ATTACHMENT A, DESCRIBING THE REVISED CIRCUITRY AND VERIFICATION PROEEDURESTO THE CONTROL CIRCUIT MODIFICATION.....

Donald C. Cook Nuclear Plant  
Docket No. 50-315  
DPR No. 58

ATTACHMENT A

## DONALD C. COOK NUCLEAR PLANT UNIT 1

# Donald C. Cook Nuclear Plant Unit No. 1

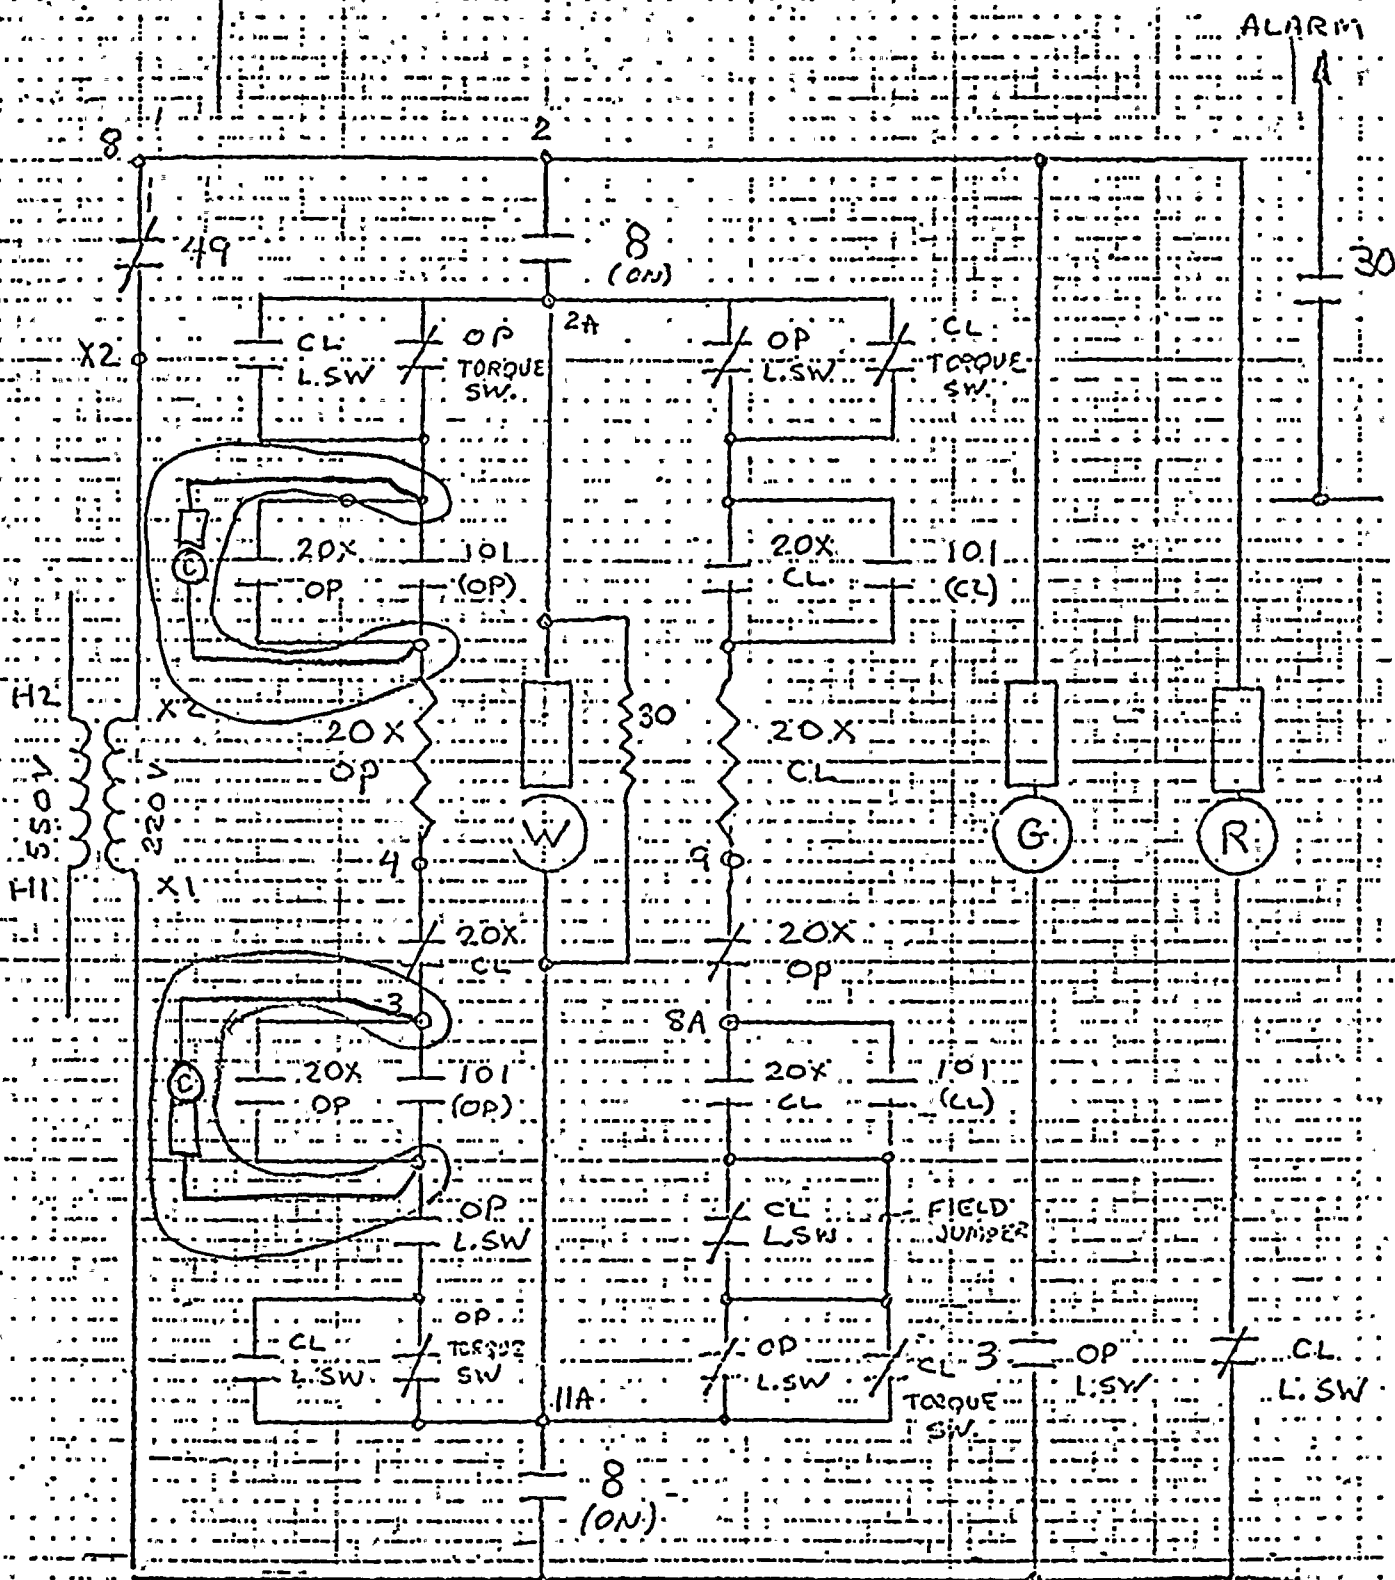
The control to the valves in question will be modified to provide a means of locking out control power independent of the normal valve control equipment and master control switch. The action of locking out the control power will remove power from the valve contactor coils and associated limit, seal in and torque switch circuits, but not remove power to the valve position indication, thus allowing the continued visual indication of valve position on the control panel in the vicinity of the Master Control Switch.

The control power lockout will be accomplished by inserting the contacts of a control switch (one per valve) between the control transformer and the valve positioning contactors.

In addition to the lockout switch, a key-lock assembly will be provided on all master control switches (101), a set of supervisory lamps will be provided across the master control switch contacts in the starter circuit for the direction of concern for spurious valve travel, and a supervisory light and alarm relay will be provided to indicate availability of control power and to alarm the annunciator system. Surveillance testing for the subject valves will follow the following procedures: Item I for outage surveillance where the valve may be repositioned, and II for in-service surveillance where the valve control circuit must be verified but the valve must not be repositioned.
